Subject: **Bid No. 8055-M4, East Park Improvements – Little League Field / DPWP**

### **ADDENDUM NO. 2**

## **ADDENDUM NUMBER TWO**

**Project:** East Park Improvements – Little League Field  
City of Worcester Dept. of Public Works and Parks; Parks, Recreation and Cemetery Div.

OK approved as noted  
08-14-2018

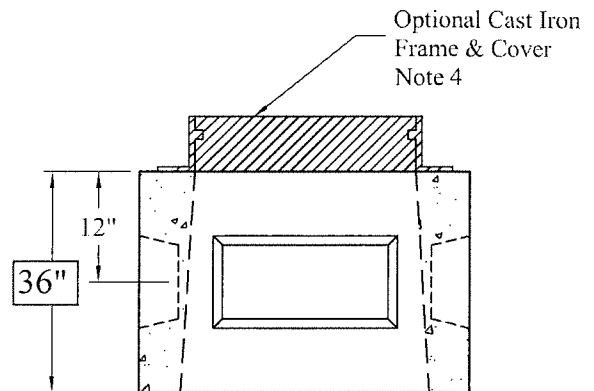
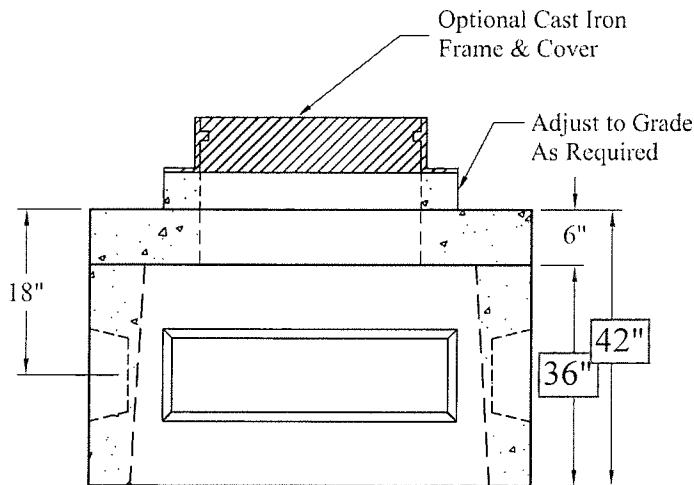
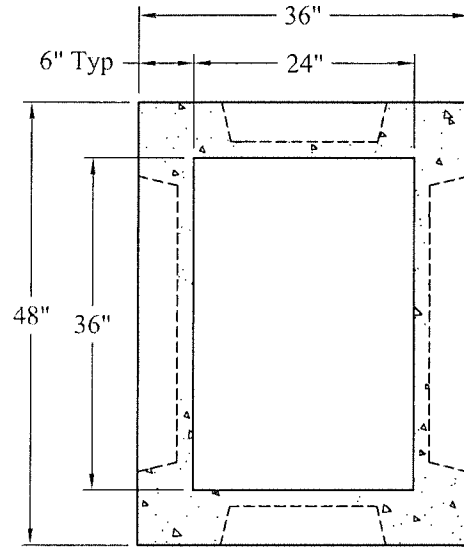
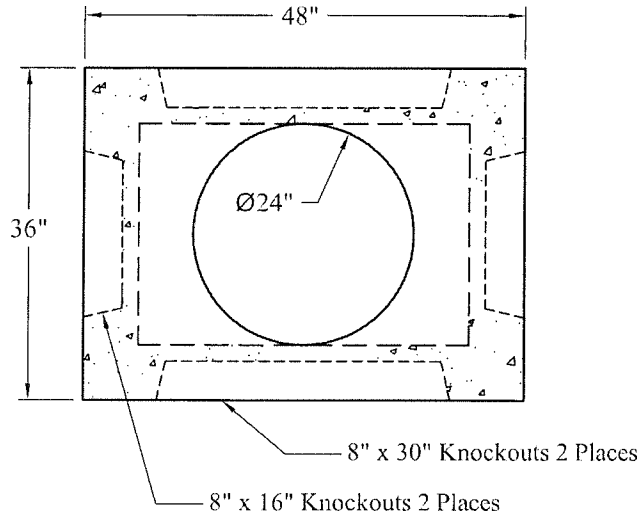
- d. Communication HH (24"x36"x36") and electrical HH (12"x24") shall be as per attached shop drawing from South Worcester Playground Project, approved 08-14-2018 or approved equal.

**C7.6**

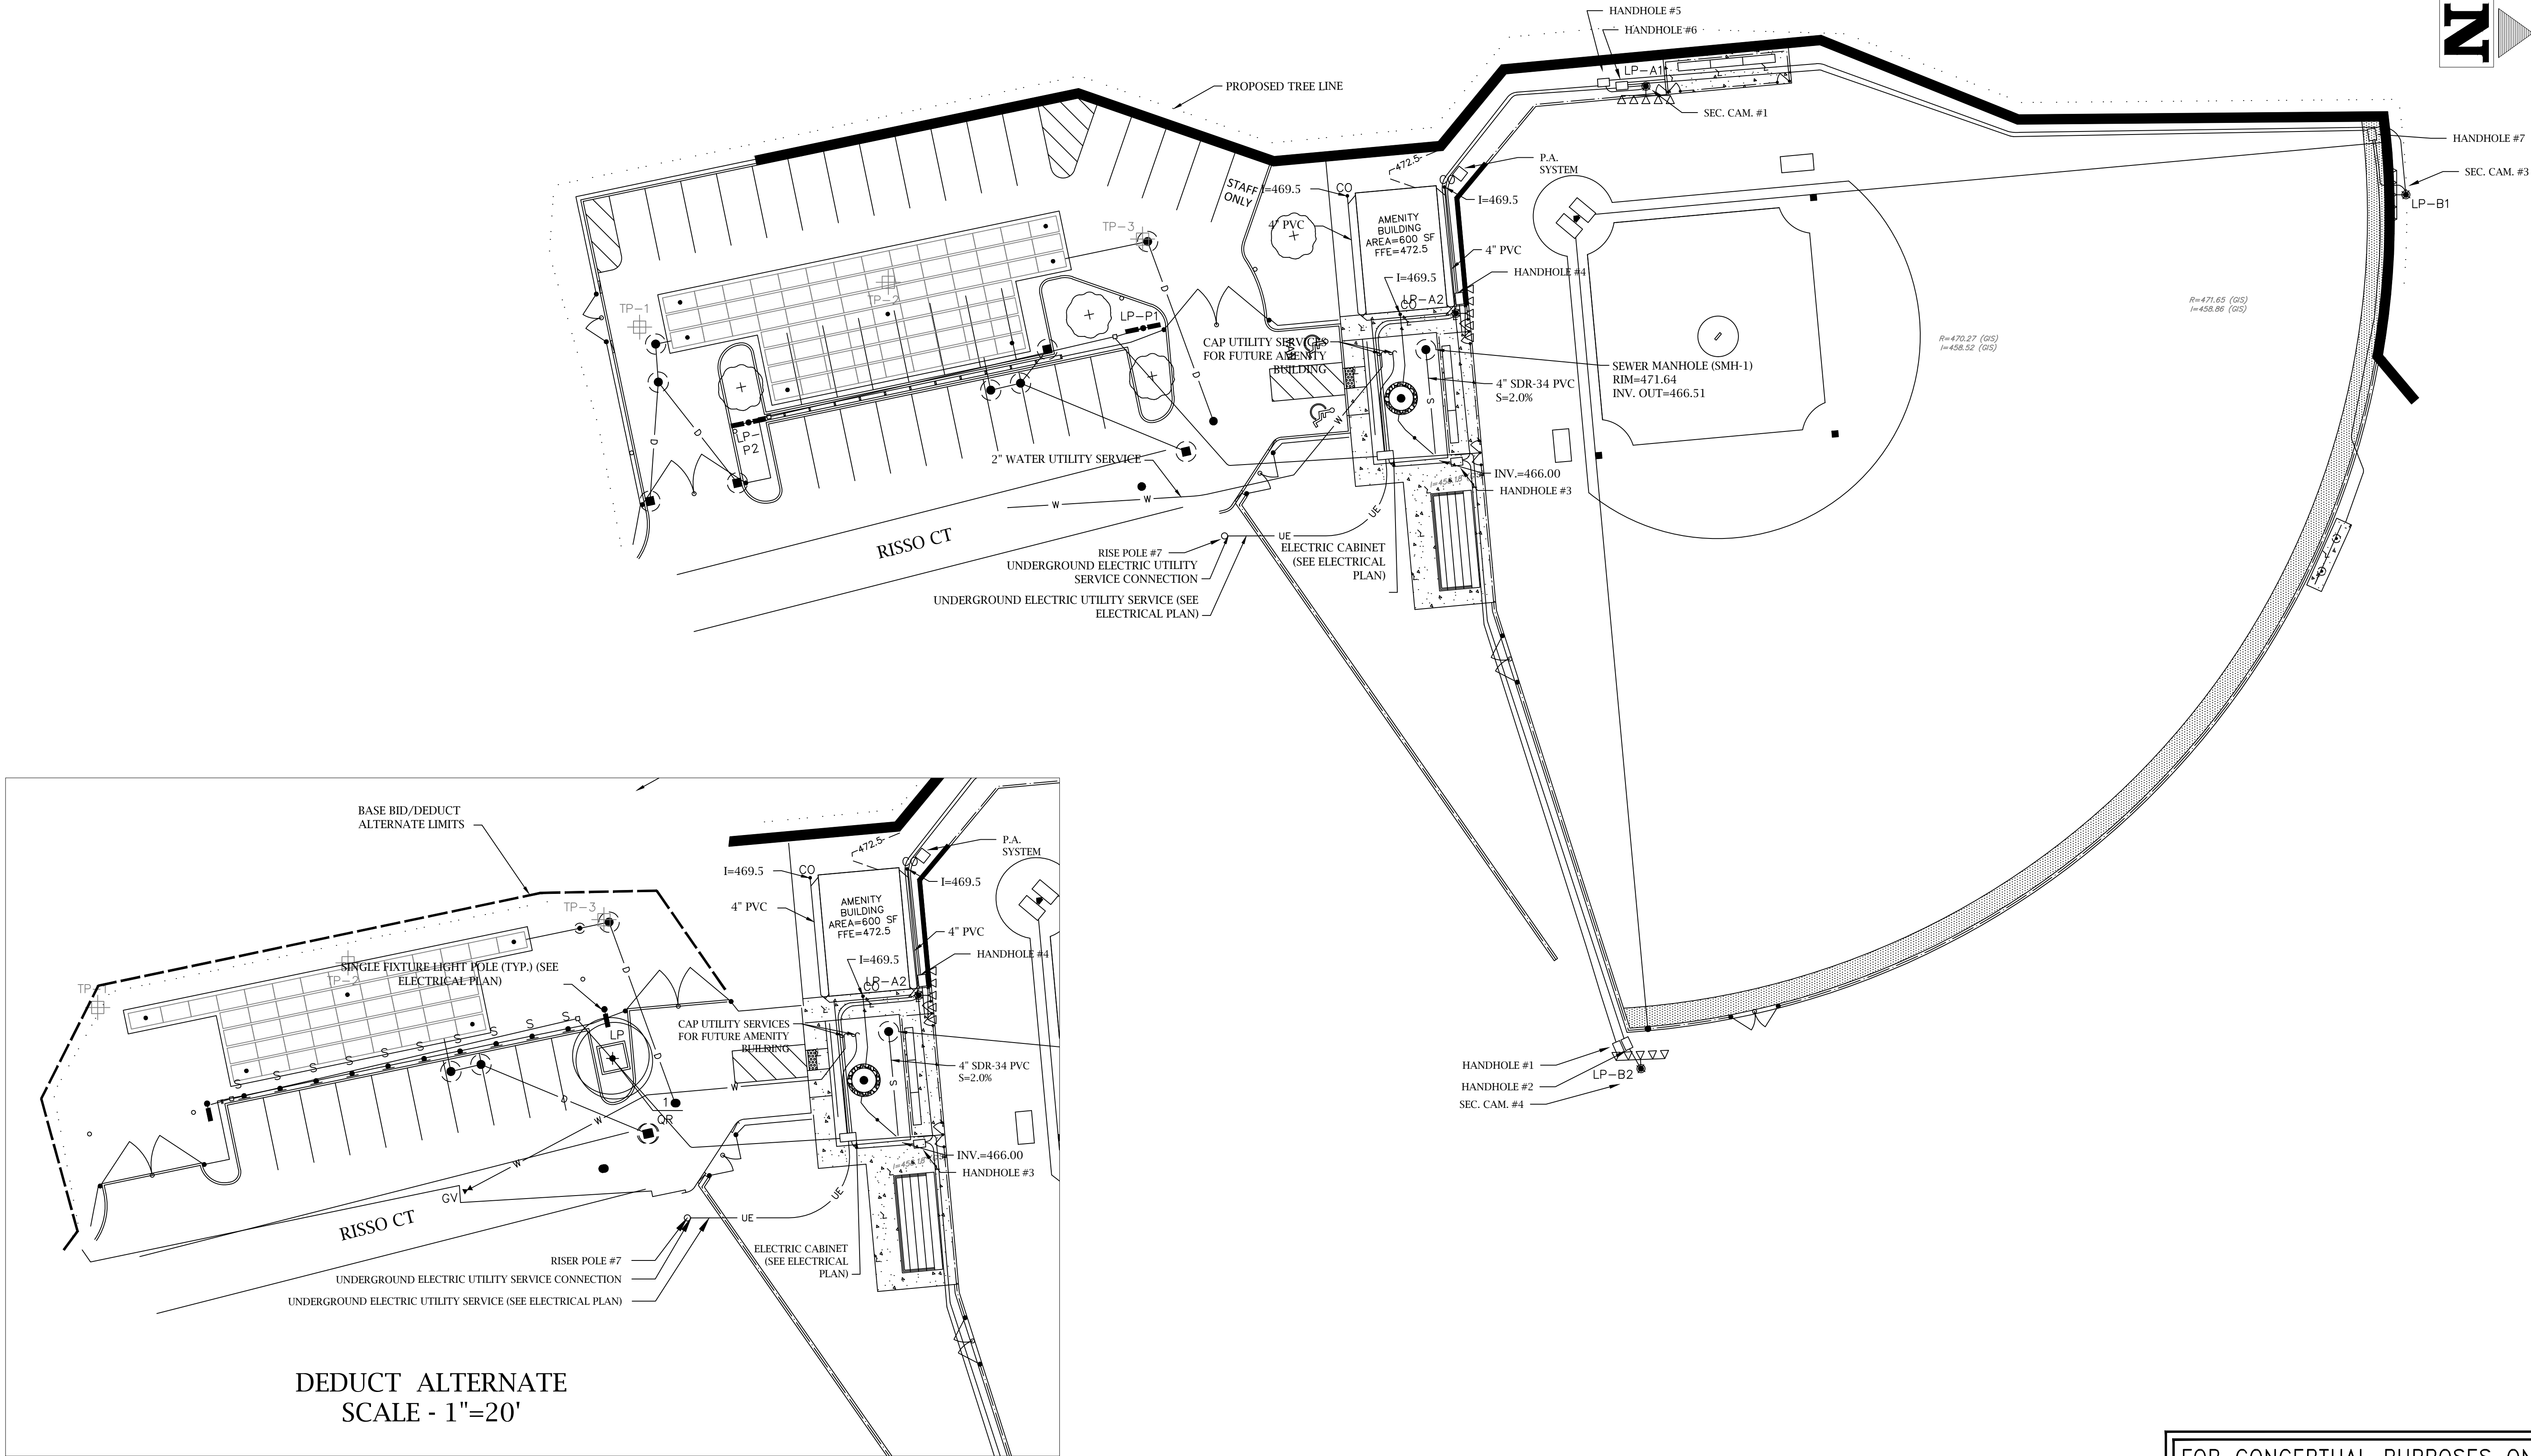
- k. Delete Sheets:
  - i. C3.1 and C7.6, dated 08/07/2023 and E-1, dated 07/25/23 and replace with C3.1 and C7.6, dated 08/16/2023 and E-1, dated 08/16/23.
